Form C-103
Revised July 18, 2013

WELL API NO. 30-015-23001	
5. Indicate Type of Lease STATE <input type="checkbox"/> FEE <input checked="" type="checkbox"/>	
6. State Oil & Gas Lease No.	
7. Lease Name or Unit Agreement Name Loco Hills Welch	
8. Well Number 2	
9. OGRID Number 228937	
10. Pool name or Wildcat Empire Morrow South (Gas)	
11. Elevation (Show whether DR, RKB, RT, GR, etc.) 3521.2' GR

Loco Hills Welch #2
#529900-002
Empire Morrow South Field
API #30-015-23001
N-004-18S-29E Eddy County
660' FSL & 1980' FWL

Wellbore Status as of:
Proposed

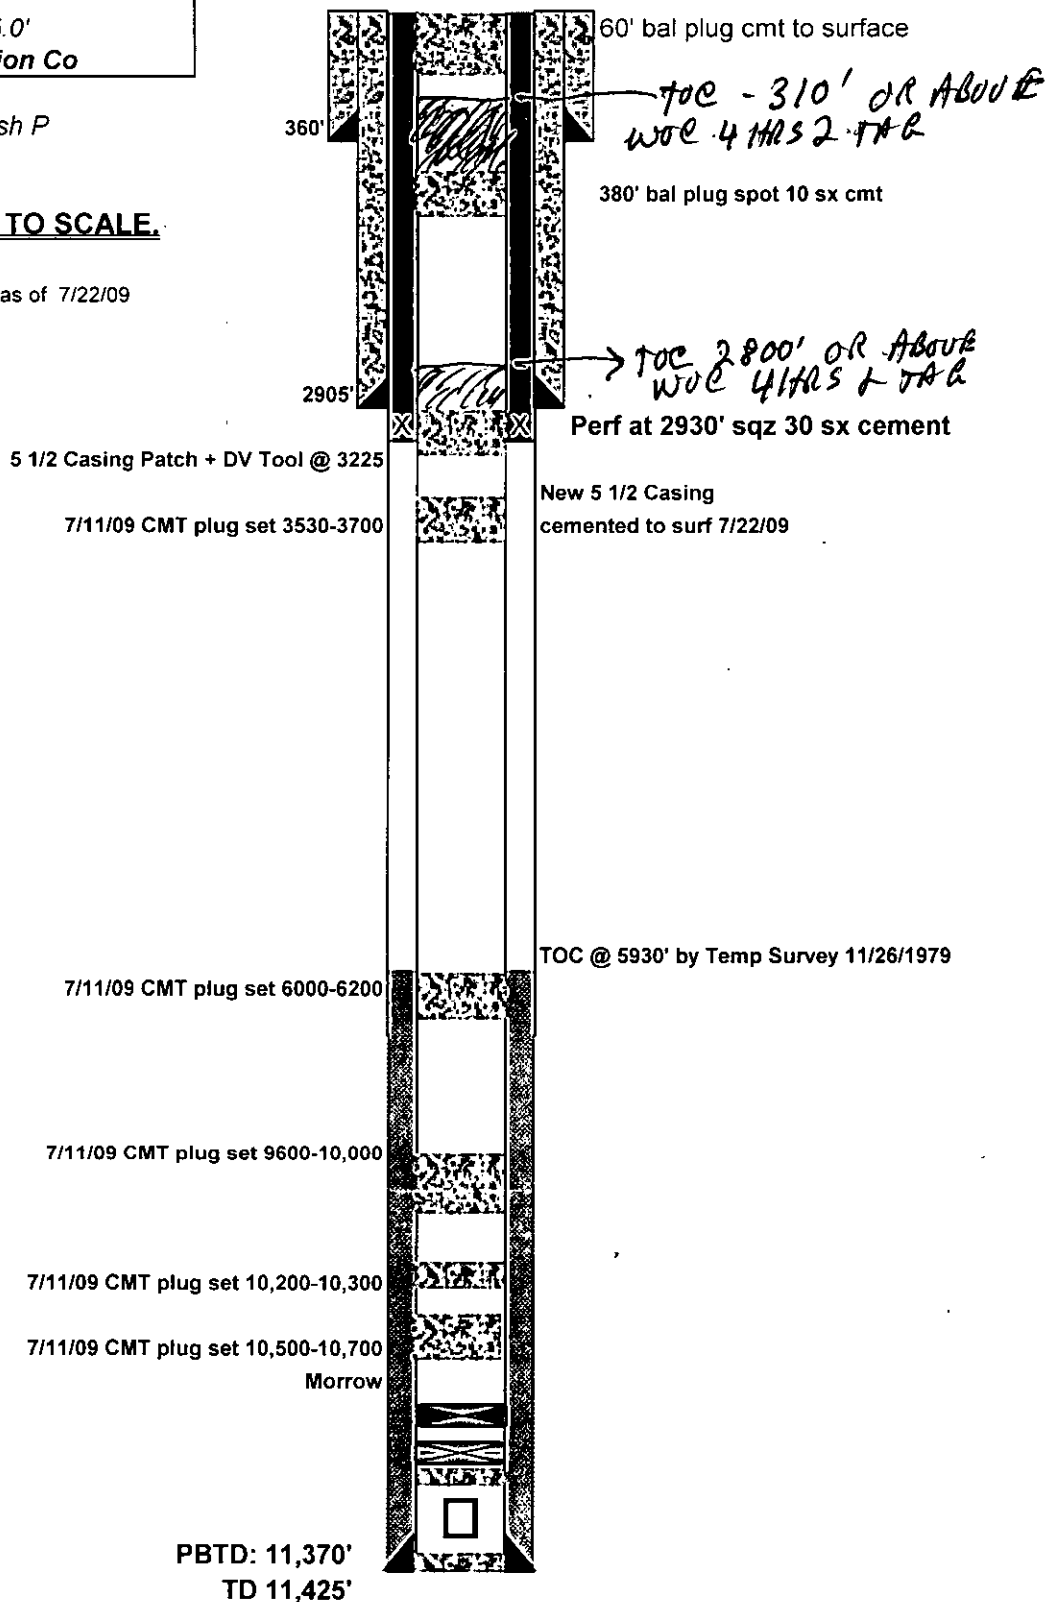
- 1) MIRU PU.
 - 2) ND wellhead to 2-3/8" 5M tubing head.
 - 3) RIH w/ perf guns, shoot SQZ perfs @ 2,930'. POOH.
 - 4) RIH w/ 2 3/4" TBG to 2,930', SQZ perfs w/ 30 sxs Class "C" cement, WOC & TAG. @ 2880' OR ABOVE
 - 5) RIH w/ perf guns, shoot SQZ perfs @ 380'. POOH.
 - 6) RIH w/ 2 3/4" TBG to 380', SQZ perfs w/ 30 sxs Class "C" cement, WOC & TAG. @ 310' OR ABOVE
 - 7) RIH w/ 2 3/4" TBG to 60', set balanced cement plug from 60' to surf.
 - 8) Cut off wellhead 3' below GL, verify cement in annulus, set plugged well surface marker and GPS dry hole marker.
 - 9) RD aux. eqpt., clean loc.
- See Attached: Proposed Wellbore Schematic.

Approved for plugging of well bore only.
Liability under bond is retained pending receipt
of C-103 (Subsequent Report of Well Plugging)
which may be found at OGD Web Page under
Forms: www.cmrnd.state.nm.us/ocd.

WELL MUST BE PLUGGED BY 8/25/2017

SEE ATTACHED COA-S
